**AMENDMENTS TO THE DRAWINGS**

The attached replacement sheet (1/5) of drawings includes the following changes:

Figure 1

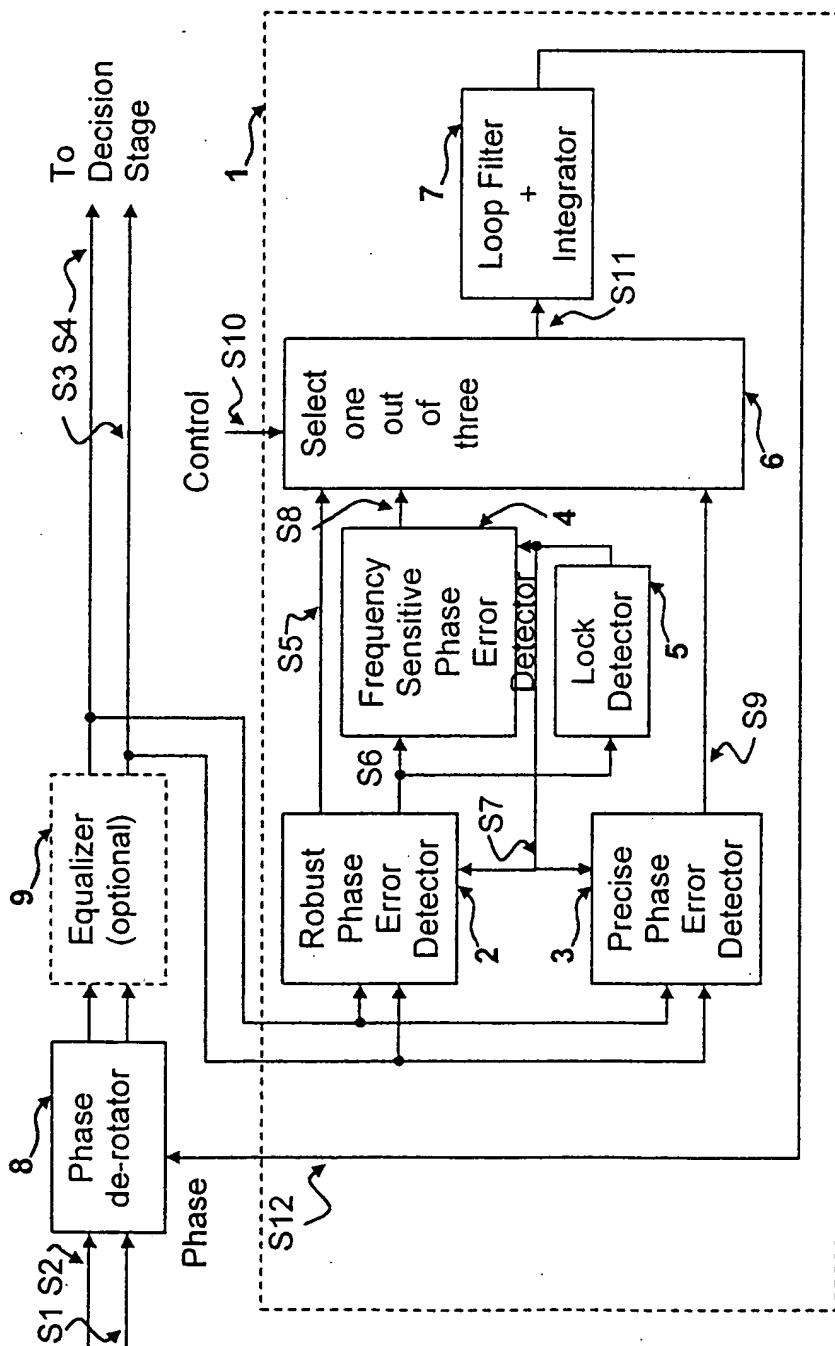
In Figure 1, please connect signal S7 (output by Lock Detector 5) to the Precise Phase Error Detector 3 as shown.
